Mitsubishi Motors North America, Inc.

TECHNICAL SERVICE BULLETIN

**HOOD FLUTTER
MY 2022 OUTLANDER**

No: TSB-26-42A-002

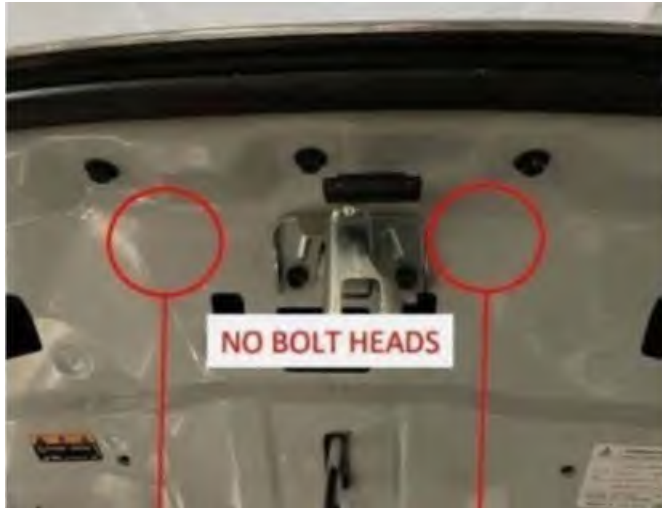
All vehicles equipped with a NON REINFORCED hood will require the engine hood to be replaced with the updated reinforced hood design.

VEHICLE IDENTIFICATION & VISUAL INSPECTION

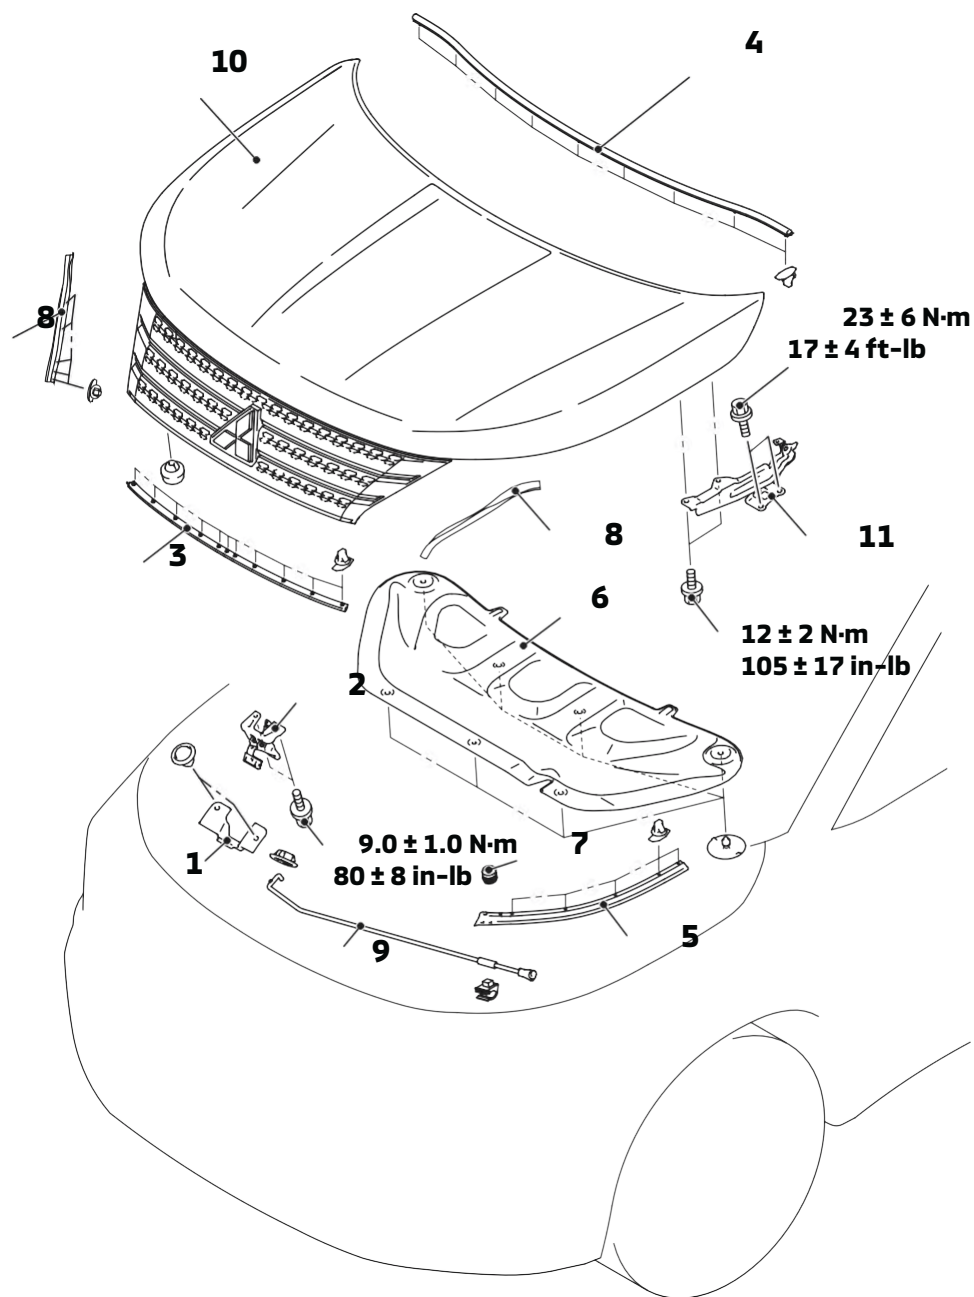
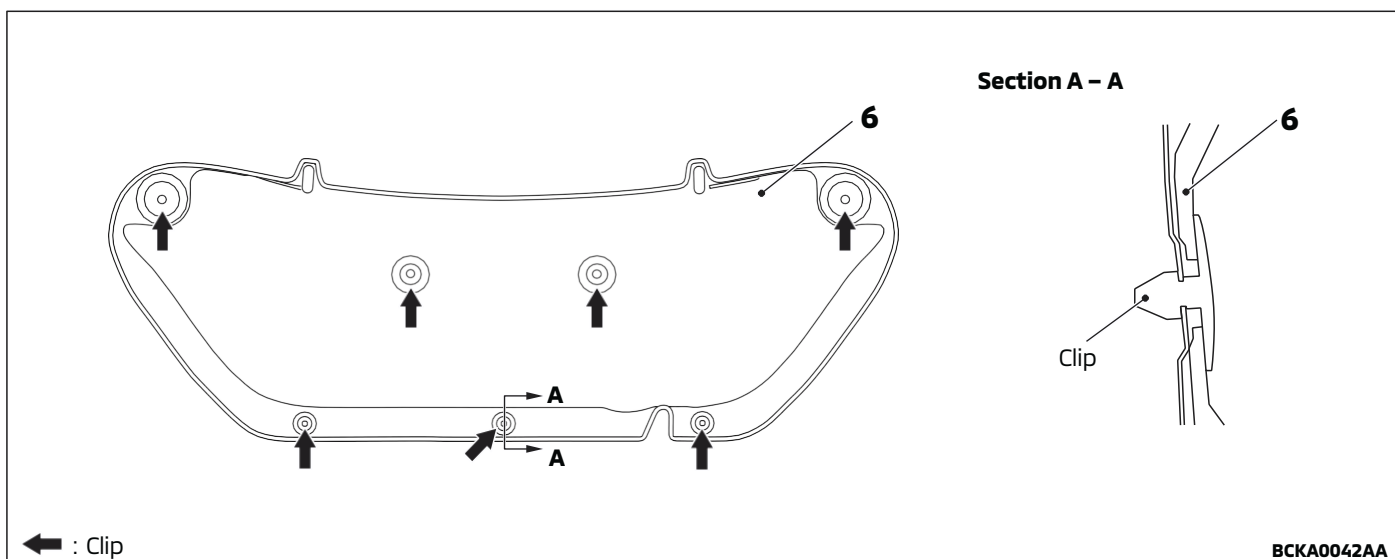
NON-REINFORCED hood: No bolt heads visible → Hood replacement is required.

REINFORCED hood: Bolt heads visible → Hood replacement is **not required.**

Any 2022 Outlander with a NON-reinforced hood **MUST** receive an updated reinforced hood, regardless of any previous repairs performed at a Mitsubishi dealership for hood flutter issues including hood replacements with a NON-reinforced hood.
